Wisconsin Department of Transportation

Proposal #20: 4010-20-71, WISC 2020 256
Sheboygan Falls – Sheboygan
CTH EE Intersection
STH 28
Sheboygan County

This is Addendum No. 01, which provides for the following:

Addendum No. 01
ID 4010-20-71
Revised Sheet 66
May 4, 2020

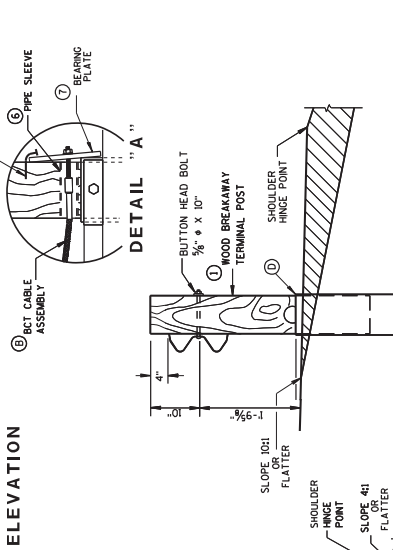
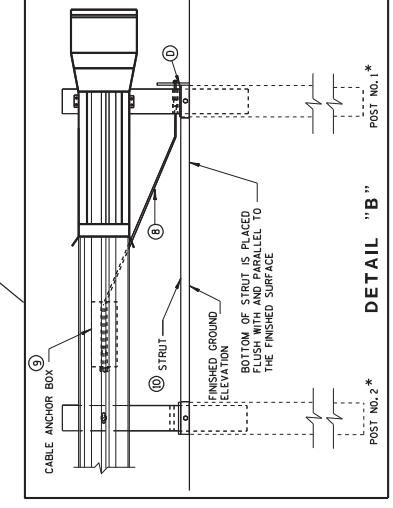
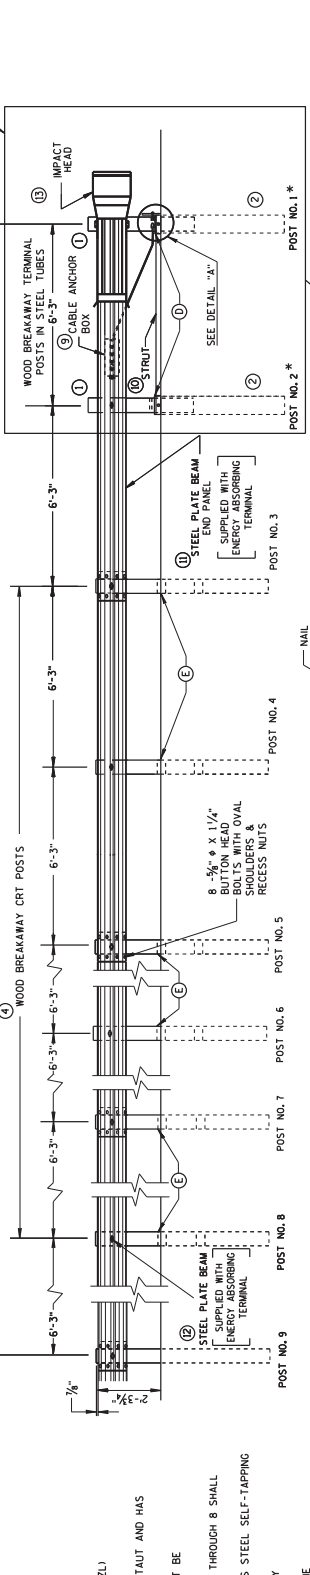
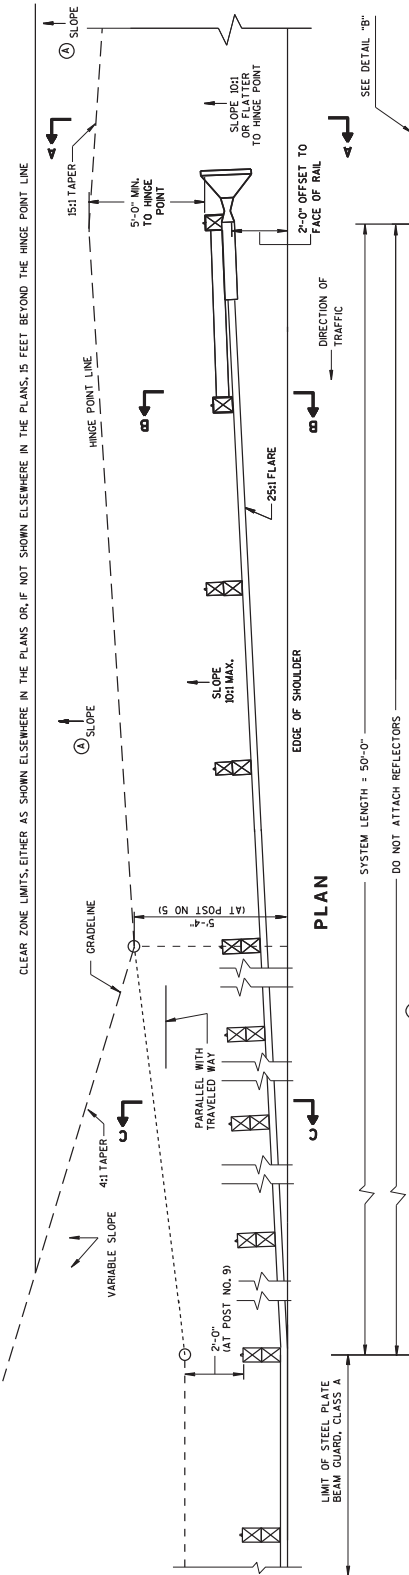
Revised Plan Sheets	
Plan Sheet	Plan Sheet Title (brief description of changes to sheet)
44	Traffic Control – Stage 1B (added notes allowing partial guardrail removal, the addition of a temporary energy absorbing terminal (EAT), and references to standard detail drawings)
66	Miscellaneous Quantities (Removing Guardrail quantity for stage 2 was split between stage 1 and stage 2)
